CITY OF VANCOUVER

POLICY REPORT DEVELOPMENT AND BUILDING

TO: Vancouver City Council
FROM: Director of Planning
SUBJECT: CD-1 Rezoning - 236-298 West 1st Avenue

Project Number	A101
Client	
Architect	
Scale	
Date

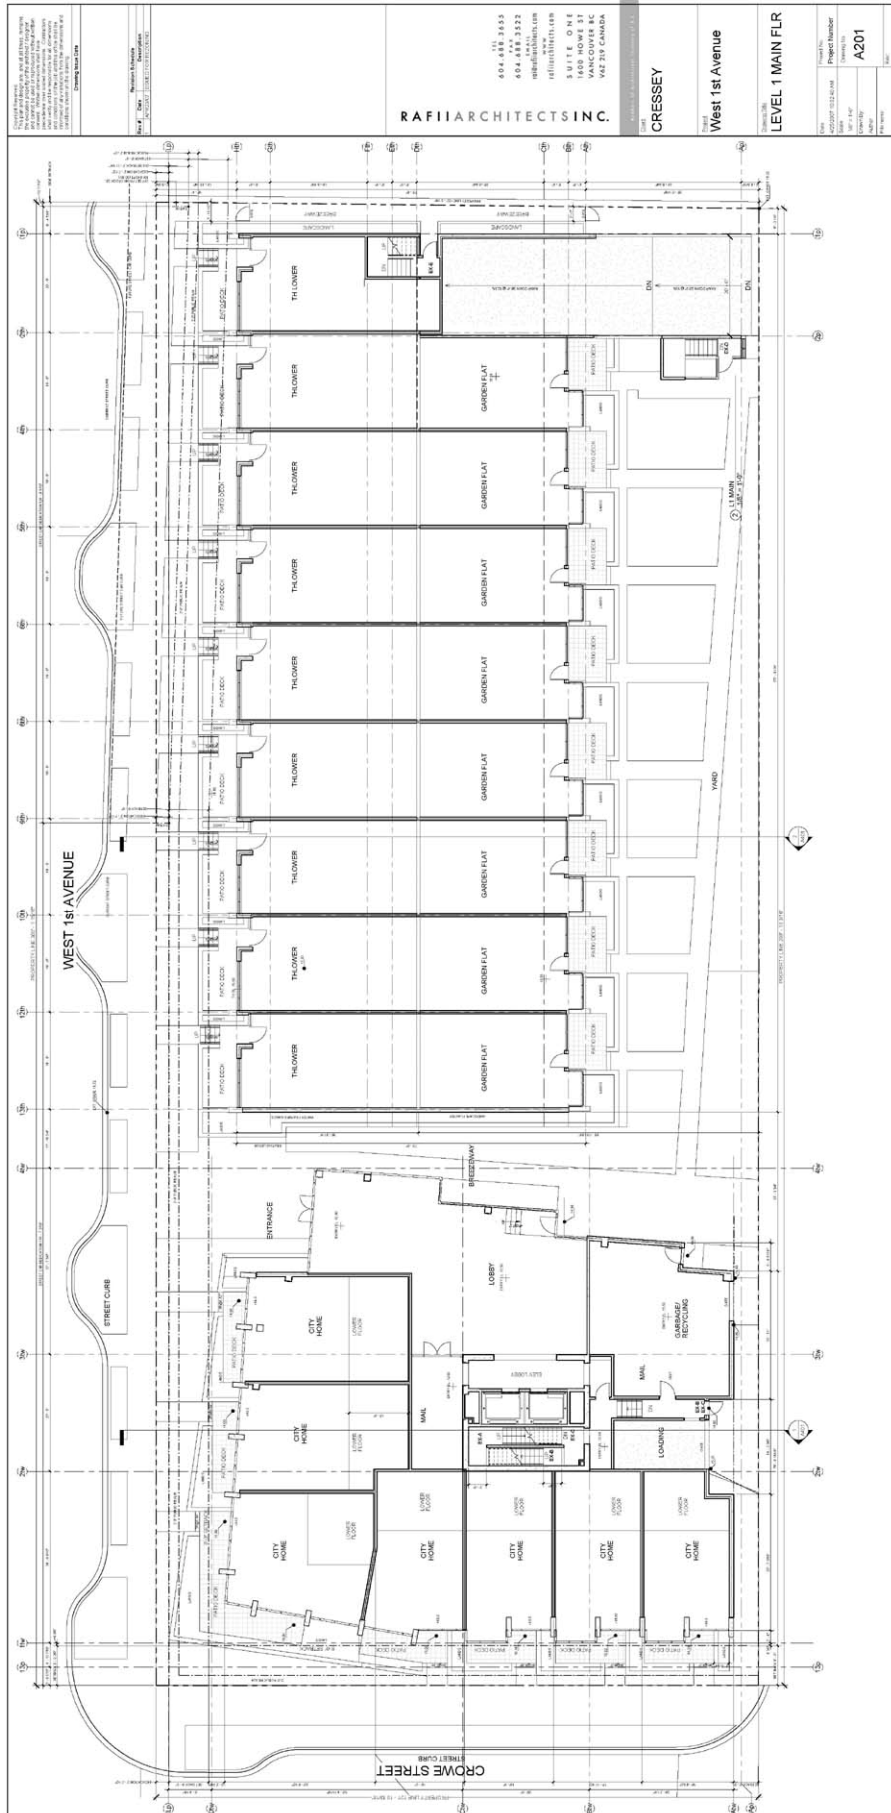
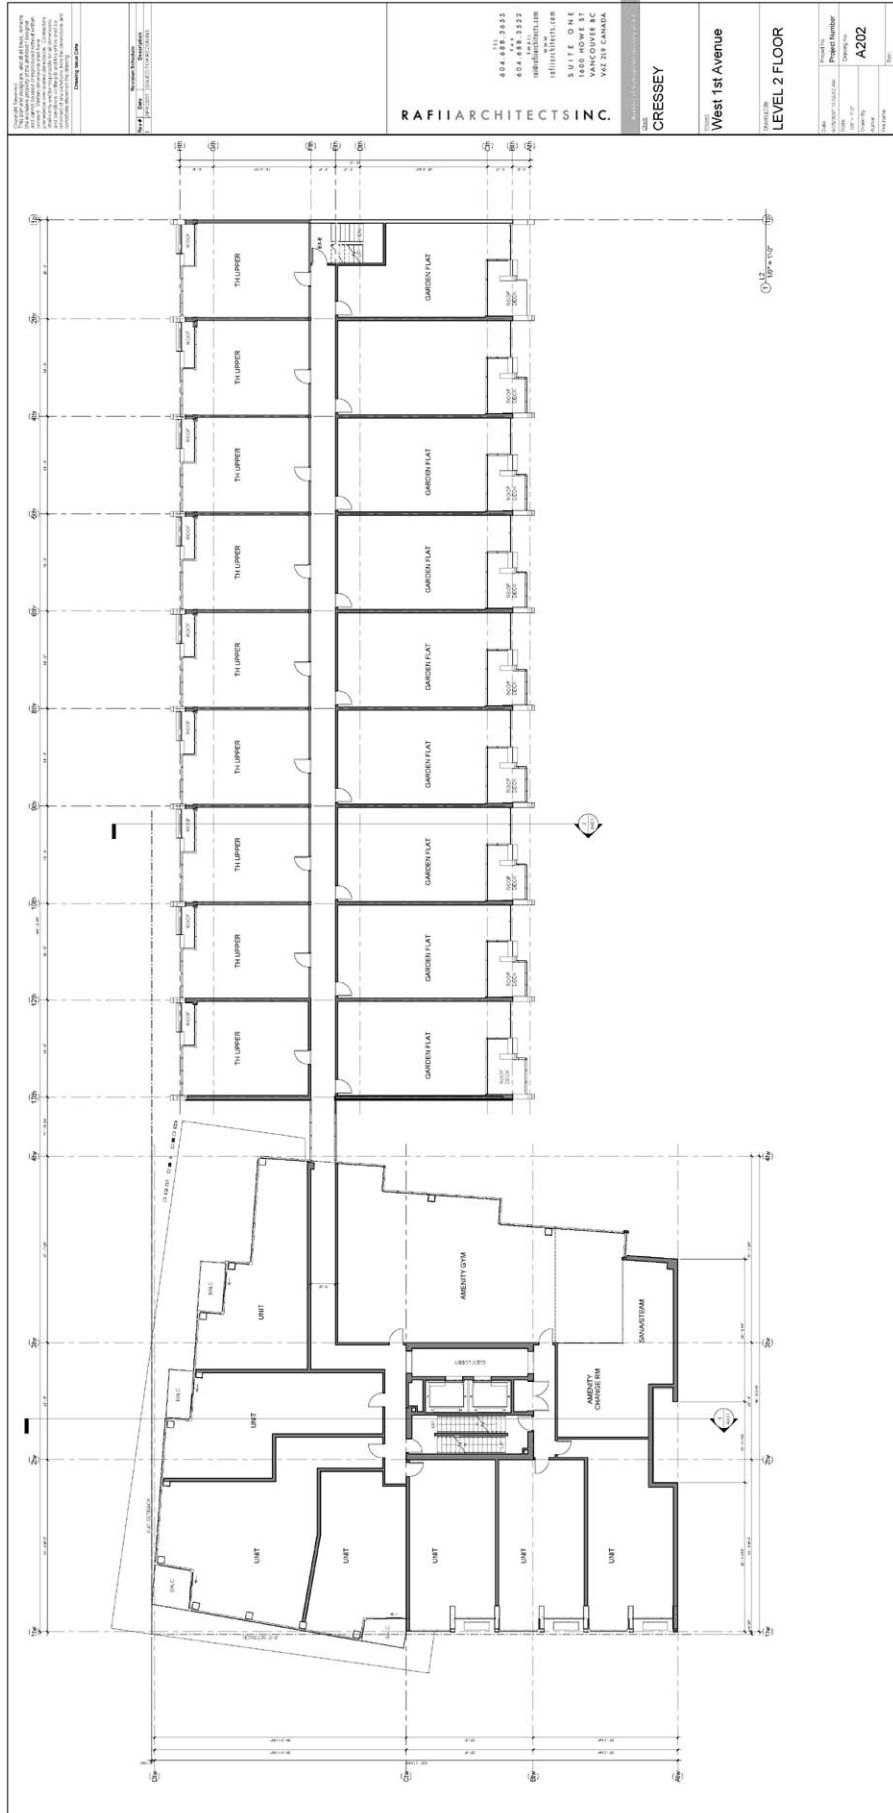
4. Clarification is required regarding the location of the future streetcar curb (drawing A201). Ensure that a minimum 4'-0" front boulevard and 6'-0" walk are preserved in the final streetcar alignment. Trees and walk should be located in their final position.
